Technical Service Bulletin

Topic	Front door clash with the rear door brightware Bentayga Series 21MY - 25MY
Market area	Bentley: worldwide (2WBE),China 723 Volkswagen (Anhui) Automotive CO (6723),China 796 VW Import Comp. Ltd (Vico), Beijing (6796)
Brand	Bentley
Transaction No.	2068064/5
Level	EH
Status	Released for publishing
Release date	Dec 10, 2025

Figure 1

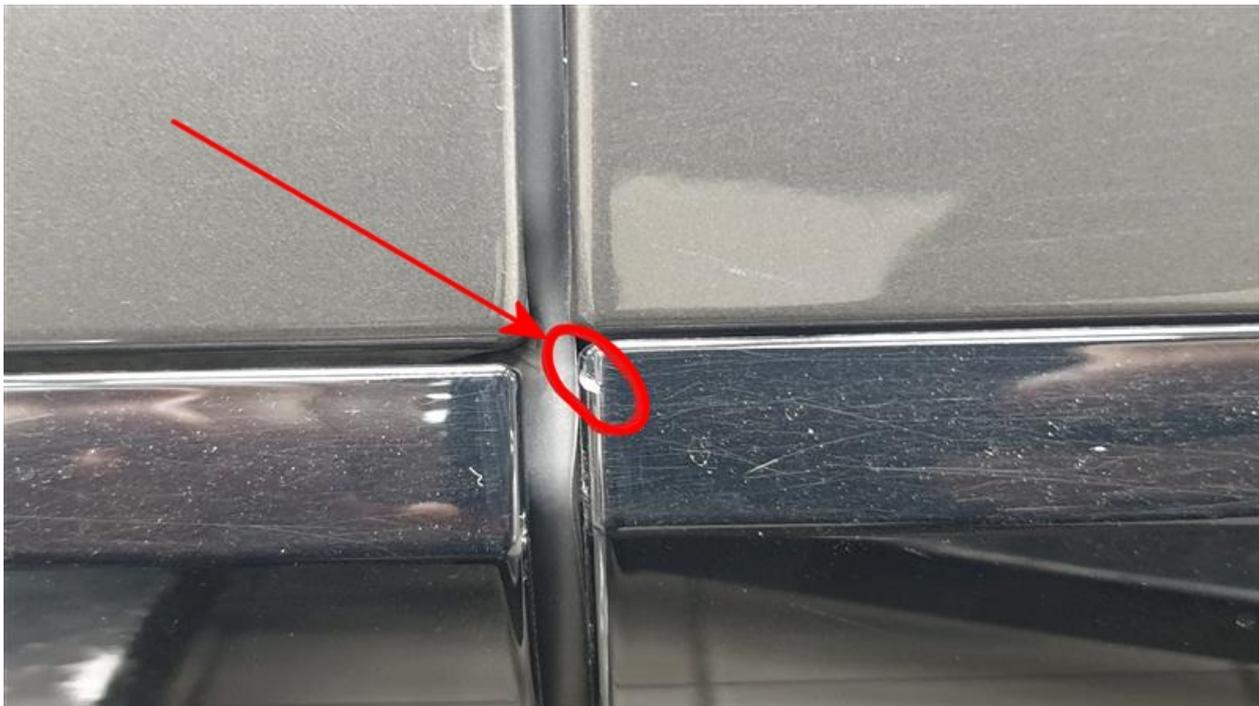
The front door inner panel hem is clashing with the rear door lower brightware (Figure 1) during the closing operation of the front door
